# Service Advisory

CC-560

## i SERIES

Subject: **Hydrostatic Transmission Dump Rod and Spring (Fix-As-Fail)**

**FIGURE 1**

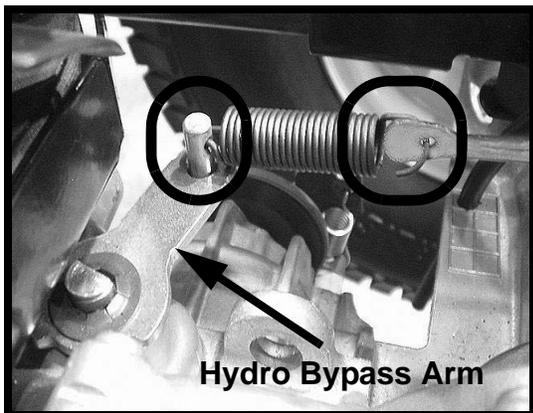
**PURPOSE:** Under certain operating conditions the spring(s) connecting the hydro dump rod to the hydro's bypass arm may come off of either the rod end and/or the bypass arm on the transmission. This results in the inability to bypass the hydrostatic transmission internal pump/motor in order to move the tractor without the engine running.

1. Place the tractor on level ground.
2. Disconnect the negative battery cable from the negative battery terminal.
3. Block the front wheels and jack up the rear of the tractor. Place jack stands under the frame rails.
4. Remove both rear wheels.
5. From the underside of the frame just forward of the transmission's axle, locate the hydro's bypass arm on the top side of the transmission.
6. If the spring is unhooked from the hydro dump rod or the bypass arm and is not damaged, reconnect. If required, replace with a new **732-0209** extension spring. If the hydro dump rod is bent or damaged replace with a new dump rod **747-04649**. See Figure 1.

**FIGURE 2**

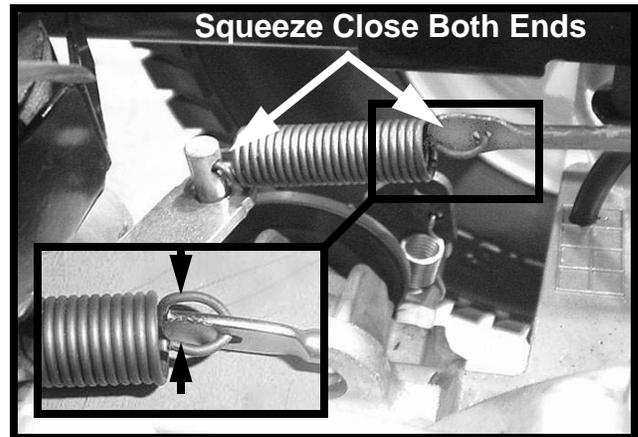
7. With a pair of pliers, squeeze both spring end hooks to reduce the hook's opening. See Figure2.
